R & G PLACE SUBDIVISION

Engineering Comments: FINAL PLAT COMMENTS (should be addressed prior to submitting the FINAL PLAT for review and/or signature by the City Engineer):

APPLICATION NUMBER 6 DATE October 3, 2019

DETAIL SITE PLAN

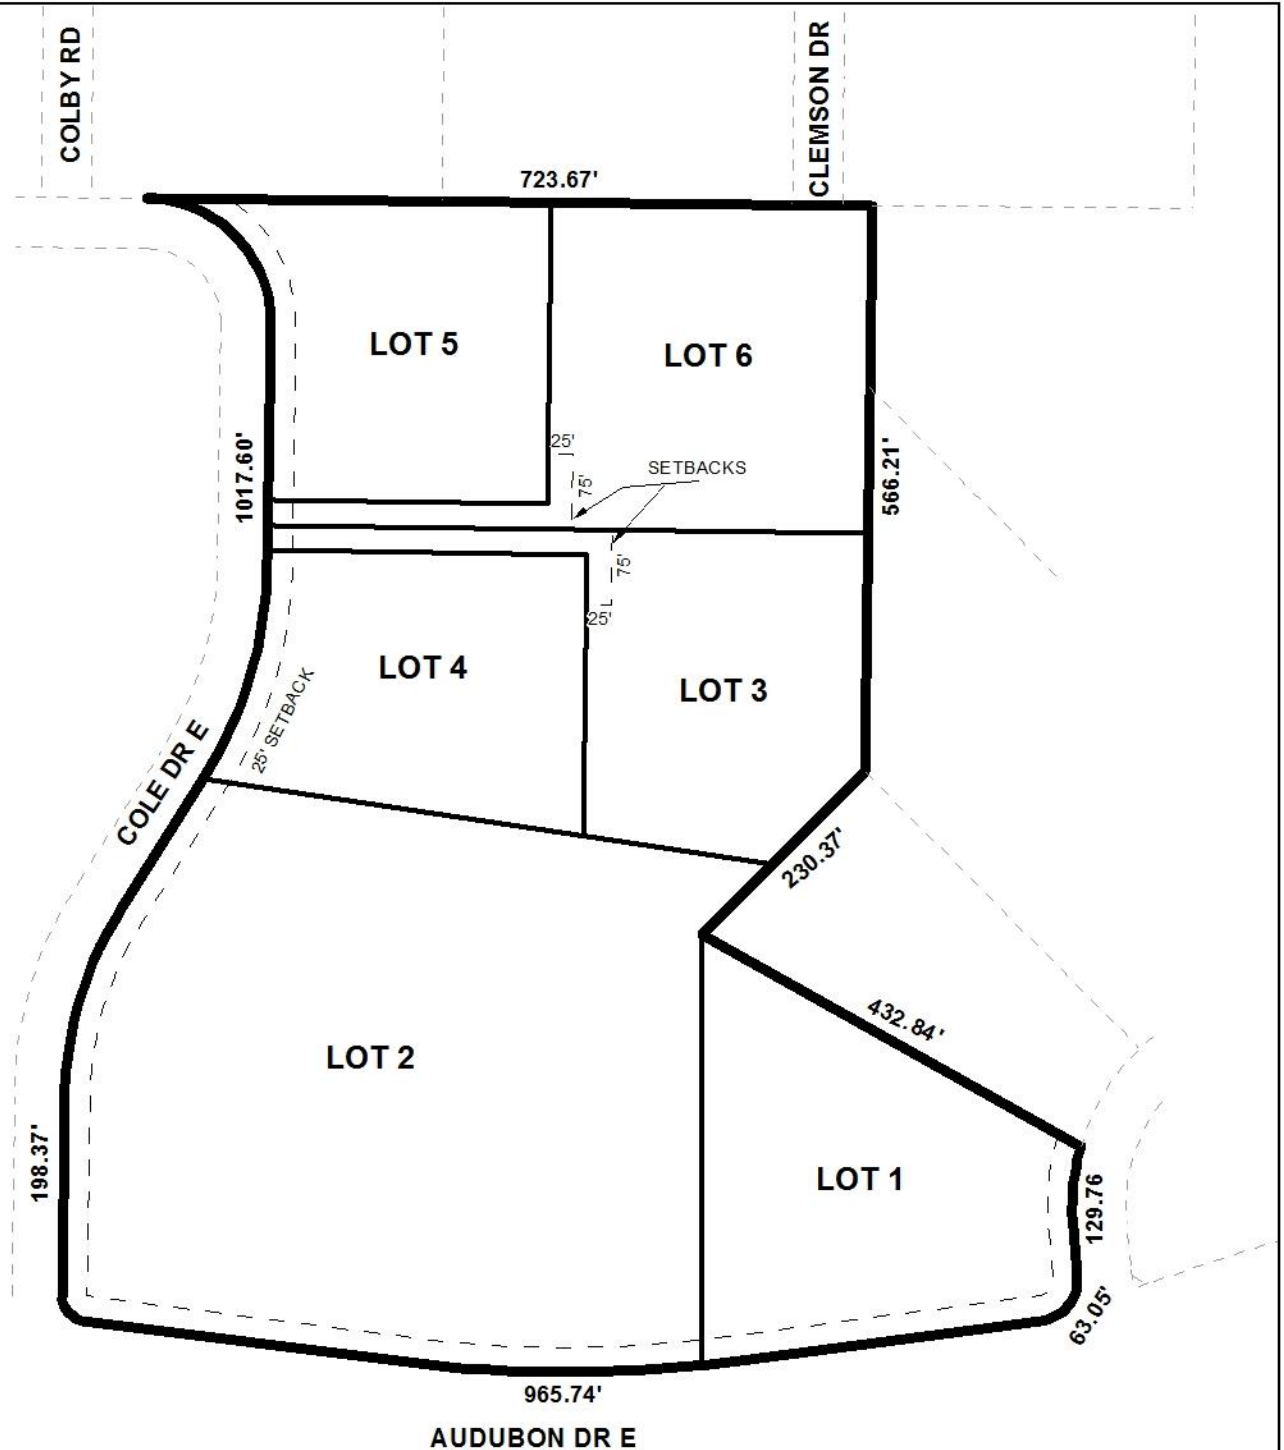
The site has frontage on Audubon Drive, Audubon Drive East and Cole Drive East, all of which are minor streets. The preliminary plat does not provide the current right-of-way widths for any of the streets, but the recorded plat for Audubon Cove Subdivision, Phase 1, indicates a 50' width for all. Although none have curb and gutter, as there was no dedication required for the previously-approved subdivision to provide 30' from the centerlines of the streets, no dedication should be required for the current subdivision. However, the plat should be revised to label each street with its current right-of-way width.

The plat indicates compliant radius curves at the intersections of Audubon Drive and Audubon Drive East, and at Audubon Drive East and Cole Drive East. As on the preliminary plat, the 25' minimum building setback line along all street frontages should be retained on the Final Plat. On Lots 3 and 6, the 25' minimum building setback line should be retained as measured from a point where the lots are at least 60' wide.

The lot size labels in both square feet and acres should be retained on the Final Plat, or a table should be furnished on the Final Plat providing the same information.

As per the Traffic Engineering comments, the driveway number, size, location and design are to be approved by Traffic Engineering and conform to AASHTO Standards. If a single shared drive is anticipated for Lots 3 and 6, then a shared access easement should be included on the plat for clarification with future development. A note should be required on the Final Plat stating these comments.

As Lots 3 and 6 are proposed as "flag" lots, a waiver of Section V.D.1. of the Subdivision Regulations would be required. While "flag" lots are typically discouraged, an allowance for such may be made if irregularly-shaped lot designs are common in the area and the informality of design is consistent with other lots in the vicinity. As Audubon Cove Subdivision, Phase 1

contains several “flag” lots, and as two of those are adjacent to the two proposed “flag” lots, a waiver of Section V.D.1. would seem in order.

- 1) revision of the plat to label all streets with their current right-of-way widths;
- 2) retention of the 25’ minimum building setback line along all street frontages on the Final Plat;

- 3) retention of the 25’ minimum building setback lines for Lots 5 and 6 as measured from a point where the lots are at least 60’ wide;
- 4) retention of the lot size labels in both square feet and acres on the Final Plat, or the furnishing of a table on the Final Plat providing the same information;

- 6) *placement of a note on the Final Plat stating the Traffic Engineering comments: (Driveway number, size, location and design to be approved by Traffic Engineering and conform to AASHTO Standards. If a single shared drive is anticipated for Lots 3 and 6, then a shared access easement should be included on the plat for clarification with future development.);*
